US 61479140-02

Float in the handbrake fitting

Figure 1:

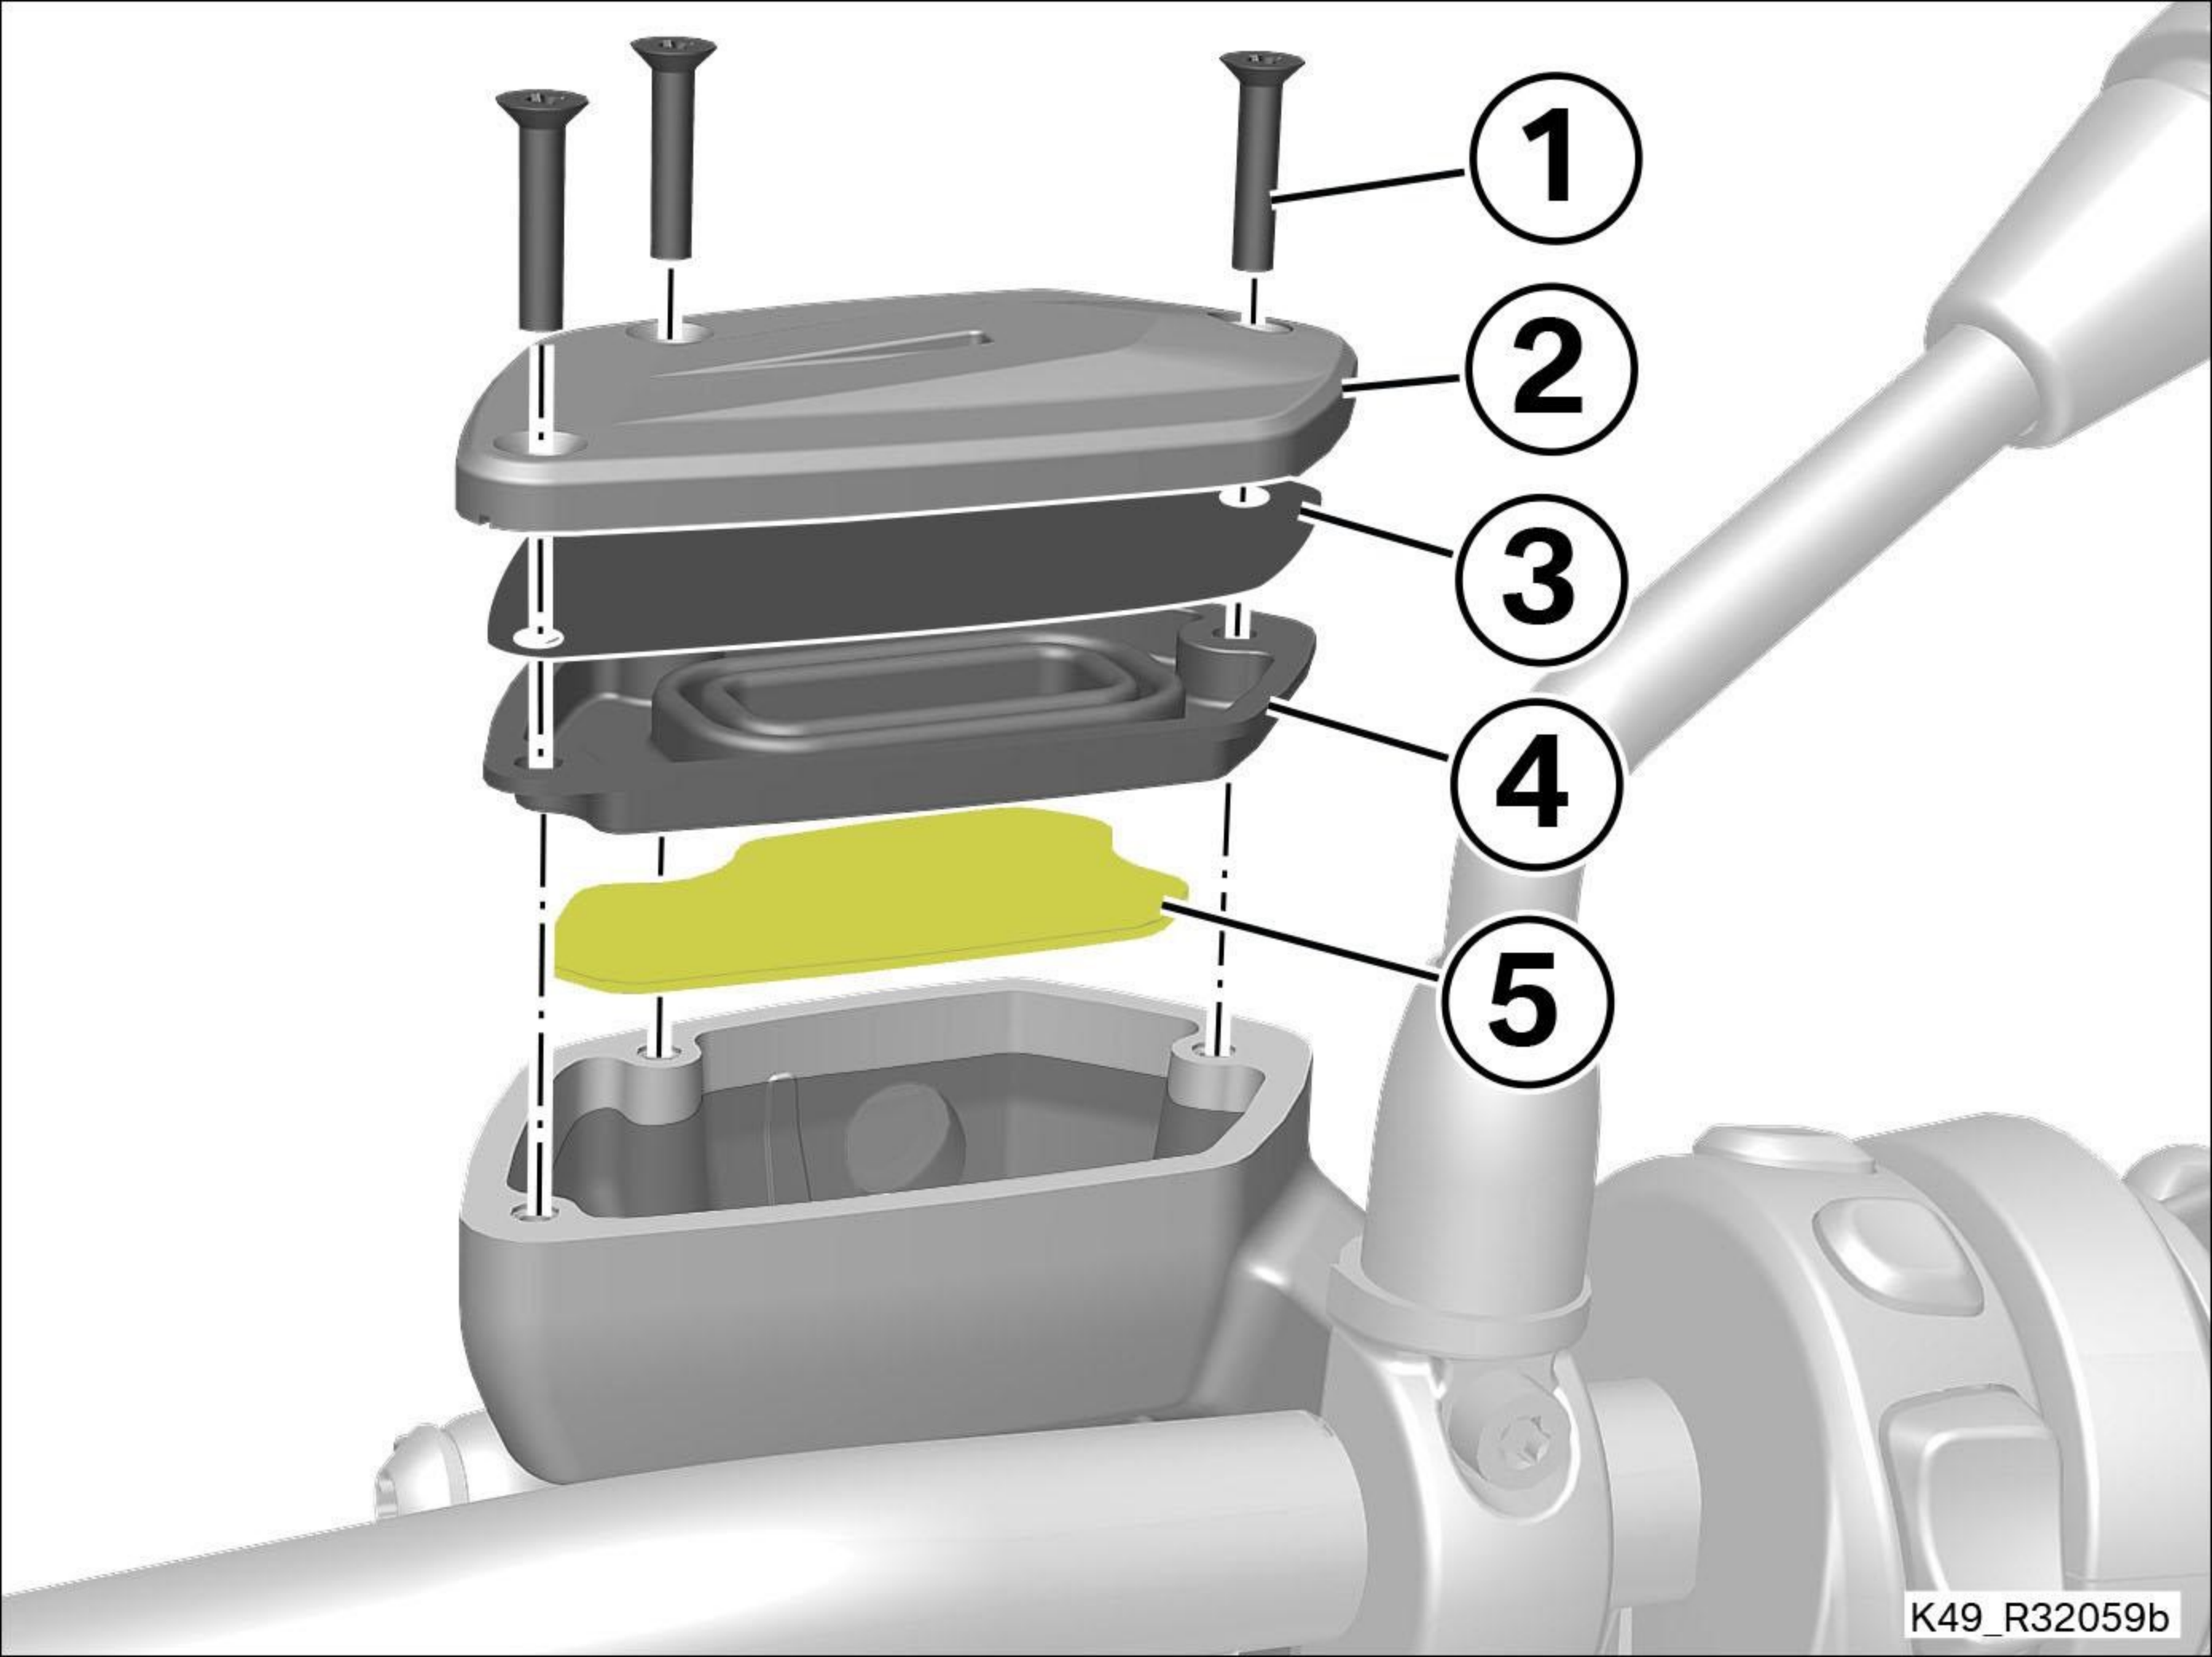
When the brake system is filled with fluid for the first time in the assembly plant, a float is installed in the fluid reservoir of the handbrake fitting (see illustration 1 and 2 in the attachment). This is only required for the assembly plant filling.

If a float remains installed, it is not possible to clearly read the brake fluid level. To improve the readability, the float must be removed before the vehicle is handed over to the customer.

On all vehicles concerned, the float (5, fig. 1) must be removed from the handbrake fitting's expansion tank before the delivery to the customer. You must then check and, if required, correct the brake fluid level.
